Project Name: UHNBC Cardiac – Phase 1 Biomed 3rd Floor

Project Number: N662030002

End of Addendum No. 3

2.4 Section 22 05 00 Clause 3.9 Testing and Inspection

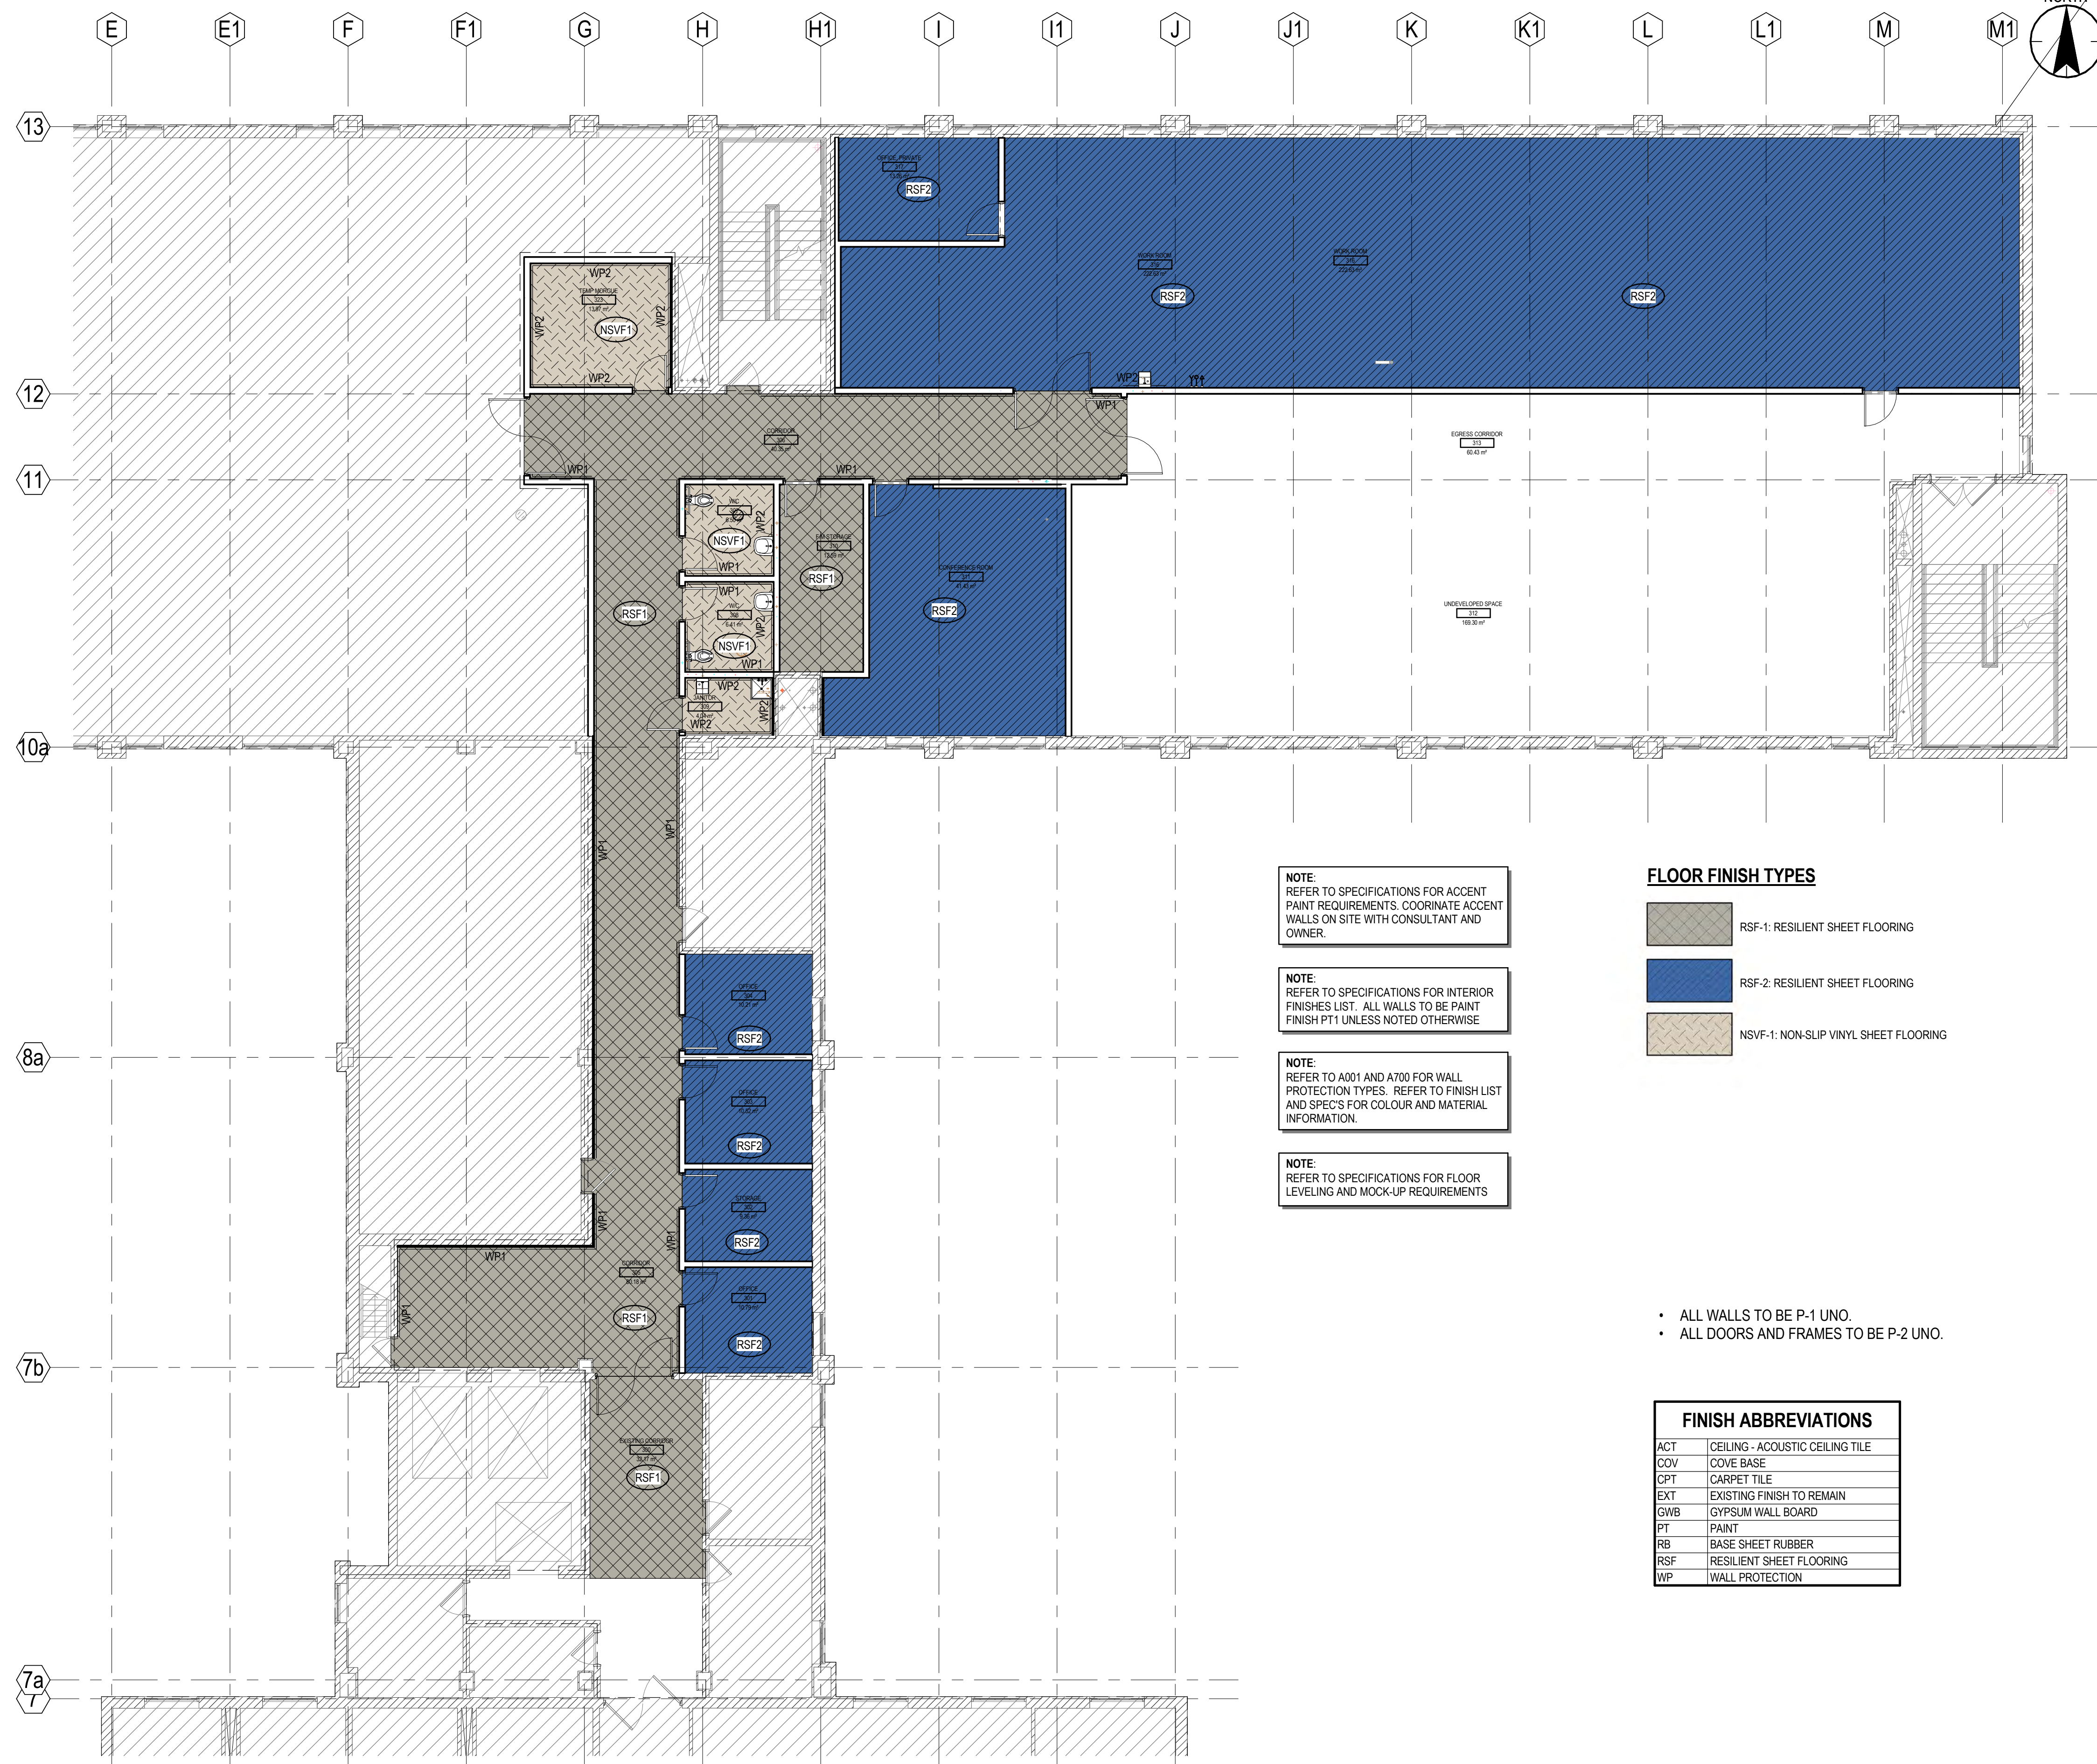
REVISE item 3.9.3 to be read as "No plumbing system or part thereof shall be covered until it has been inspected and approved by the Plumbing Inspector and UHNBC Facility Maintenance (FM). UHNBC FM should have an opportunity to inspect and approve the systems"

Replace section 22 05 00 in its entirety with revised section. The clause numbering has been corrected.

Title
FLOOR FINISH PLAN - LEVEL 3

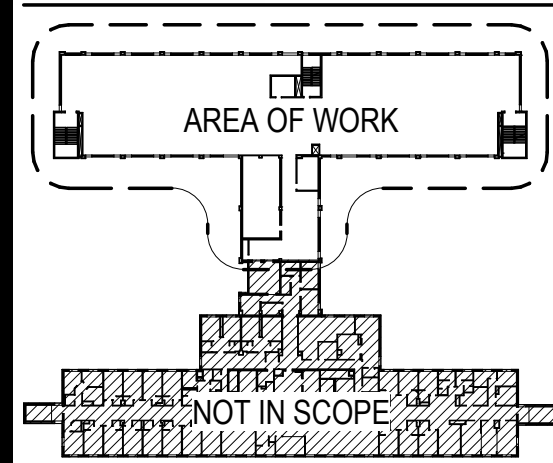
Replace Armstrong Flooring products with Tarkett iQ Granit as the basis of design to match existing facility flooring standards. Standard color RSF-1 and RSF-2 to be Soft Fleece.

Delete CPT-1. Replace all CPT-1 with RSF-1.

3.1 DRAWING A900

Replace with attached revised Drawing A900.
